Re: S/D 98-37 -- Final Plat of HEATHER ADDITION

Re: S/D 98-37 -- Final Plat of HEATHER ADDITION

METROPOLITAN AREA PLANNING COMMISSION

CASE NUMBER: S/D 98-37 - HEATHER ADDITION

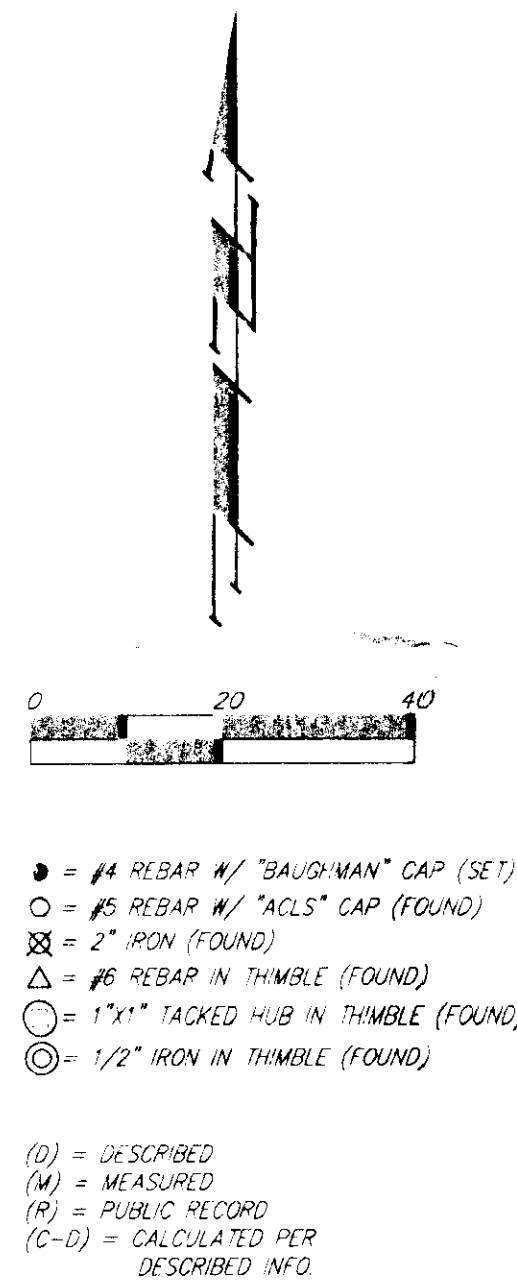
- A. Existing municipal services appear to be available to this site. City Engineering needs to verify if any other guarantees are required. No additional guarantees are needed. Woodland Street contains substandard pavement and an affidavit not to protest future paving to City standards will be required of the applicant.
- B. If improvements are guaranteed by petition, a notarized certificate listing the petitions shall be submitted to the Planning department for recording.
- C. City Engineering needs to comment on the status of the applicant's drainage concept. The drainage plan is approved. A cross-lot drainage agreement is needed or a drainage easement needed to be denoted on the plat along the western line (coinciding with the utility easement).

- D. Traffic Engineering needs to comment on the need for access controls along perimeter streets, and additional right-of-way. Traffic Engineering requests an additional 20-foot of right-of-way along 29th Street North. Complete access control along 29th Street North is required along the westernmost portion of the northern lot and the east 70 feet. Along Woodland, 50 feet of complete access control will be required from the intersection.

- G. The applicant needs to revise the legal description to accurately portray the land being platted. The distances on the drawing are not identical to those in the legal description.

A drainage easement has been denoted on the plat as requested.

The additional right-of-way and access controls have been included on the final plat.
